REGIONAL REVIEW FINDING

ARC REVIEW CODE: R1610101

Name of Proposal: Palmetto Distribution Center (DRI #2594)

PALMETTO DISTRIBUTION CENTER DRI
City of Palmetto
Natural Resources Division Review Comments
September 7, 2016

DRI PLAN
PALMETTO DISTRIBUTION CENTER
PALMETTO, GA
MAY 26, 2016

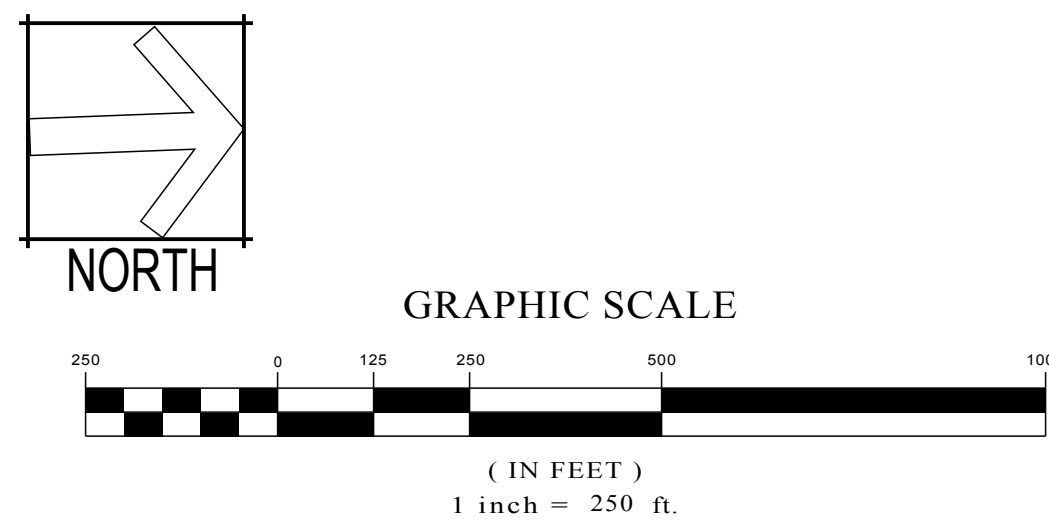
There are no existing bicycle and pedestrian facilities along SR 29 adjacent to the site. The site plan does not depict proposed sidewalks or crosswalks for internal or external access to the site. The traffic study does discuss making considerations for sidewalk and pedestrian access from nearby bus stops to the site.

access to the site from Wilkerson Road as well as designated vehicular parking throughout the site. The information does not denote any separation between vehicular and truck traffic via lanes internal to the site.

The traffic study discusses proposed improvements that include additional turn lanes and a traffic signal at one of the proposed entrances. The site plan does not depict the proposed improvements. It should also be noted that in the summary and conclusion (pages, 1 and 33) there is discussion about a proposed traffic signal at one of the access points, however, on page 7, all access points to the site are characterized as unsignalized. To determine feasibility of the transportation improvements proposed, a conceptual design plan of the roadway and site visit are necessary.

With the proposed level of increase in truck traffic over vehicular traffic on SR 29 which will impact current LOS levels, ARC recommends careful consideration be given to both transportation system . The site plan does not depict interconnectivity between future compatible developments. ARC encourages practices that promote interconnectivity between compatible developments through provisions for both pedestrian and vehicular access means.
